THE JAGUAR AMAZON REDD+ PROJECT VERIFICATION REPORT

Project Title	The Jaguar Amazon REDD+ Project
Version	1.5
Report ID	VR_Jaguar_27032023

Report Title	TheJaguar_VCS_VerificationReport_1.4_March23
Client	Greenoxx Sociedad Civil
Pages	110
Date of Issue	27/03/2023

During the verification 18 CLs and 12 CARs were raised. All these issues were appropriately closed by means of corrections, more clear explanations, and additional supporting documents.

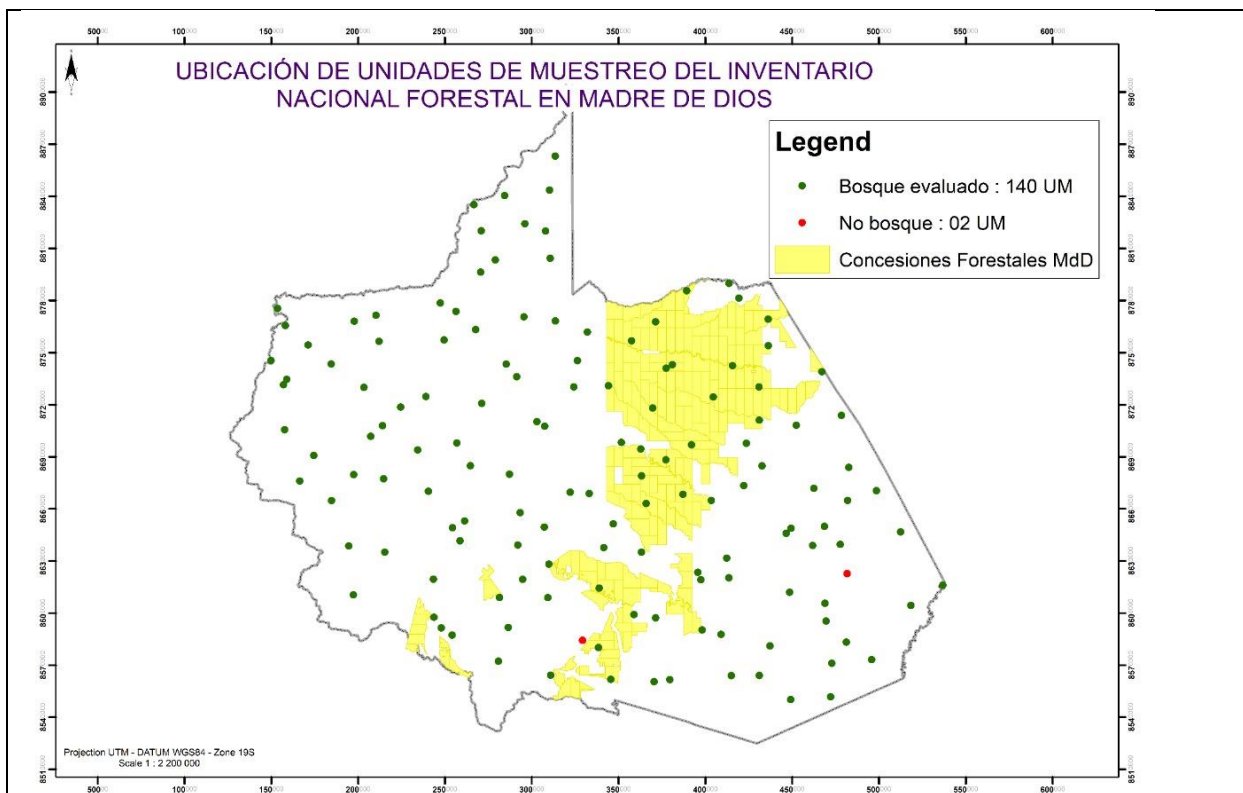
- c) The PP has correctly estimated $u_{inventory}$ for both strata. Closed.
- d) Although it has no final impact on the value of $u_{transition}$, $CE_{inventory}$ is still incorrectly estimated. EQ33 requires the use of HWCI ($OM_o(CSi)$) and $OM_o(CSi)$, i.e. organic matter. However, the PP is using tCO_2e values.
- e) Deforestation rate in the ex ante project scenario has been corrected. Closed.
- f) The PP shall provide this justification as part of a methodology deviation in the corresponding section.
- g) Values for Forest have been corrected in table 89. However, values for Pasture are no included.
- h) The PP has corrected values of $C_{harvest}(t, i)$ in table 90 considering a conservative approach. Closed.

3. Then, EQ21 is applied:

With the Excel formulae (=SQRT(SUMSQ(8.85,3.72))/361.23), we obtain the $CE_{inventory}=0.03$

4. As a result, with EQ 22, the $U_{inventory}$ for Forest stratum is still 1, so there are no impacts on the subsequent calculations.

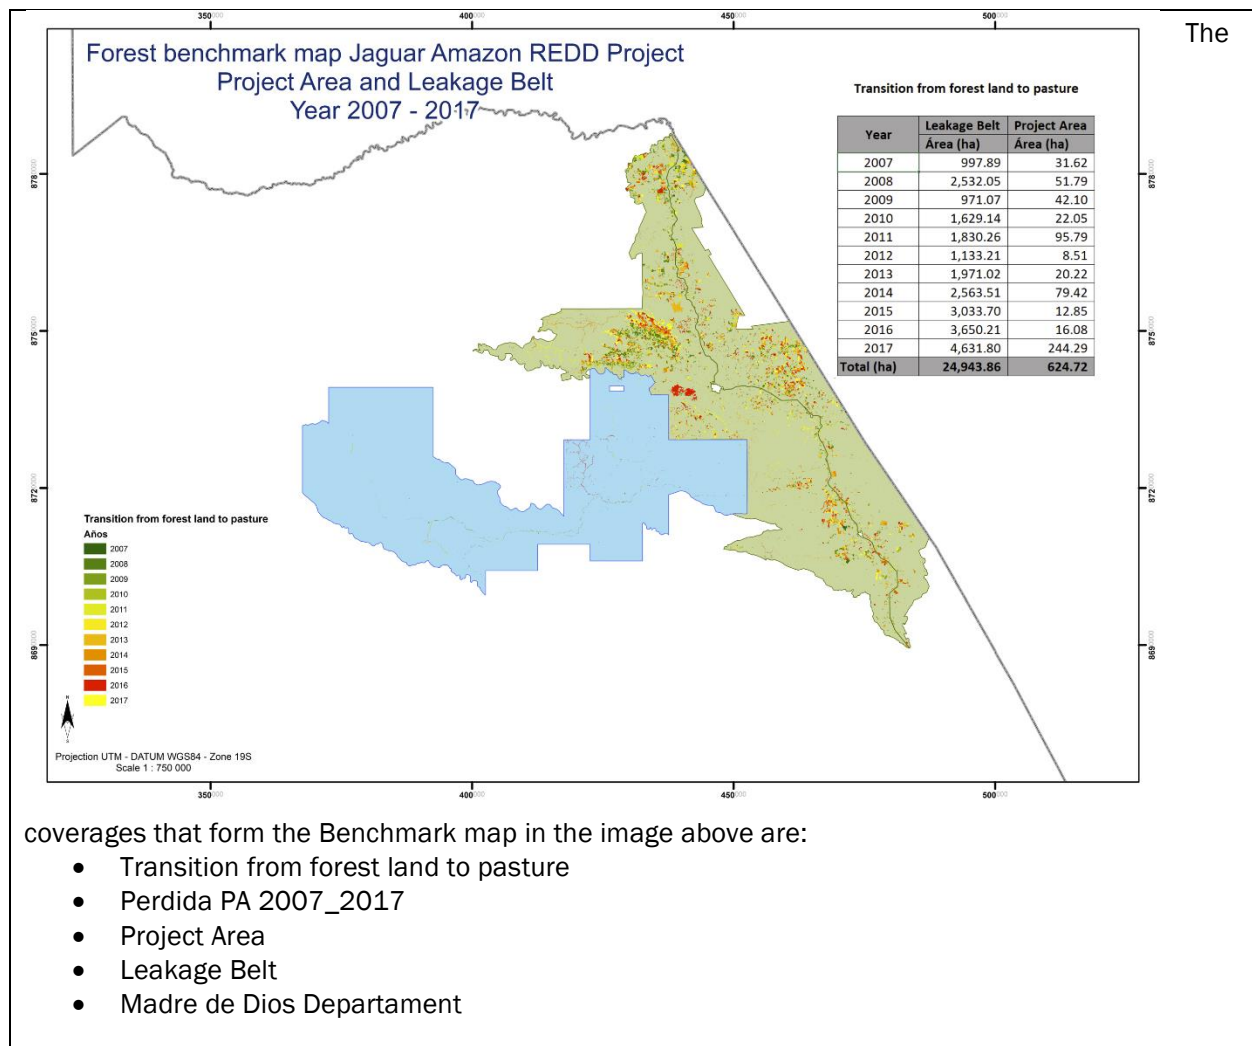
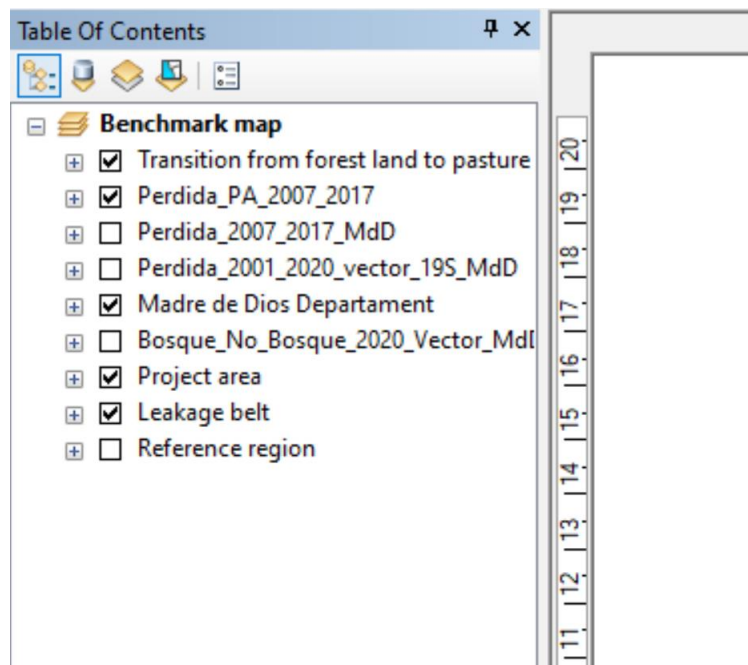
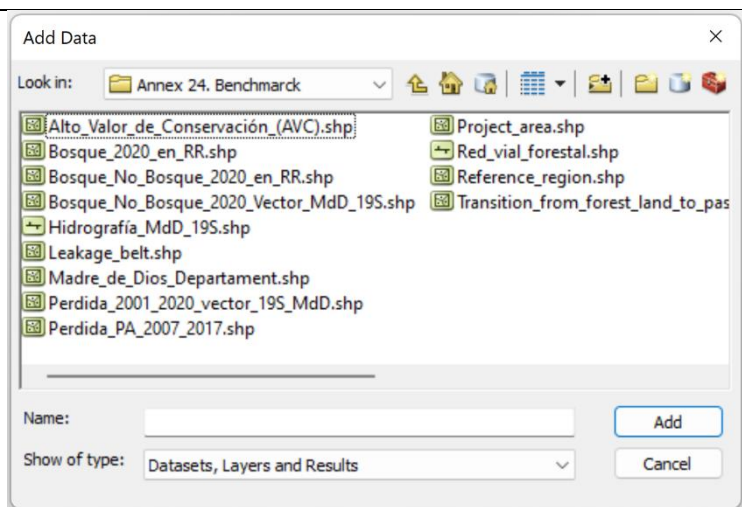
Annex 24		
VVB Assessment		Date: 20/09/222
a. The information has been updated b. It is clear d. The file has not been provided yet. f. The section has been updated		
Project proponent response		Date: 25/09/2022
Requested files may be found in Annex 24. To avoid any confusion, we have developed the following changes:

In Annex 24 of mega, we have uploaded the following shapes:

- Alto Valor de Conservación (AVC)
- Bosque 2020 en RR
- Bosque No Bosque 2020 en RR
- Bosque No Bosque 2020 vector MdD 19S
- Hidrografía MdD 19S
- Leakage belt
- Madre de Dios departament
- Perdida 2001 2020 vector 19S MdD
- Perdida PA 2007_2017
- Project Area
- Red vial forestal
- Reference región
- Transition form forest land to pasture
- Benchmark map

To avoid confusion, only those shapes that make up the Benchmark map will be left in the Mega storage, so they are removed:
